Surface Water Assessment Pit 8 Extension Modification Wilpinjong Coal Mine Wilpinjong Coal Pty Ltd 8 August 2025 1052-15-D4 - Comments

WCPL is seeking to modify Development Consent (SSD-6764) to facilitate an extension of the existing Pit 8 (the *Pit 8 Extension*) within Exploration Licence (EL) 9399 and development of associated supporting infrastructure and facilities (the Modification).

The current report has been written to try and address the questions raised by the Wollar Progress Association. Sections 1-6 of this report address the specific information requests from the Wollar Progress Association; while Sections 7-12 provide supporting evidence for these conclusions. References cited are included in Section 13.

Figure 41. Calibration Hydrographs for Gwa14 and Gwa 16 from SLR (2025c) with the observed data from SLR (2024)

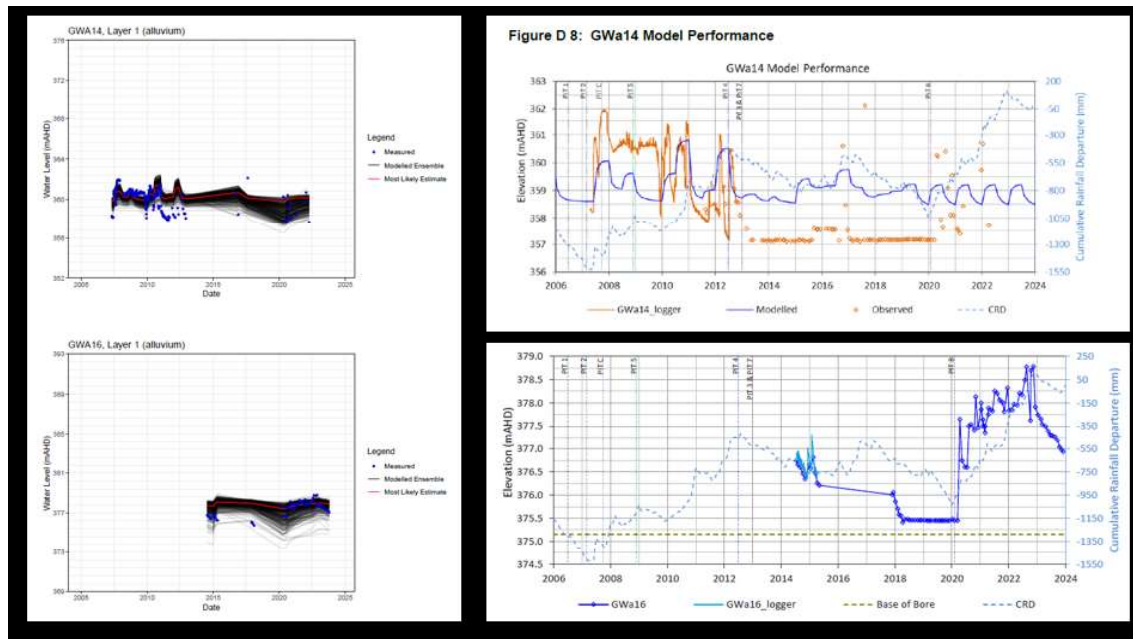
COMMENT: Another concern with many of the Calibration Hydrographs for the Pit 8 Extension Modification is that in some cases they leave out relevant observed data, particularly where some of the alluvial bores have gone dry altogether. This is illustrated by contrasting the Calibration Hydrographs for Gwa14 and Gwa 16 from SLR (2025b) with the observed data for the same bores from SLR (2024) - see Figure 41 below.
